PRODUCT / PROCESS CHANGE NOTIFICATION

PCN-000585 General

Part Number(s) Affected: <ul style="list-style-type: none"> SC4212MLTRT 	Customer Part Number(s) Affected: <input type="checkbox"/> N/A
--	---

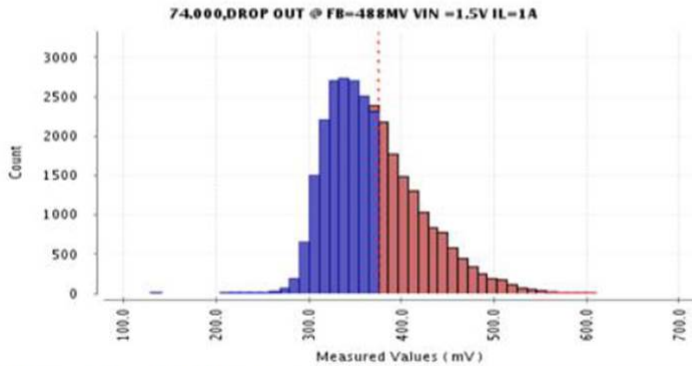
Semtech is changing the VIN parameter of the SC4212MLTRT due to a supply chain issue. This change is due to a fab process only able to support VIN = 1.6V. This parameter change affects the device Vdropout and LoadReg. These tests use VIN = 1.5V and 1A load.

The datasheet defines the dropout at 1A load to be 400mV (room temperature) and with a guardband that 375mV at Final Test. We pull the rejects and noticed that the Vout at 1A full load recover by 200mV when we start increasing the VIN by at least 1.55V.

After reviewing the fab capability, we found that the fab process is not really capable to run at 1.5V. Thus, we propose the change.
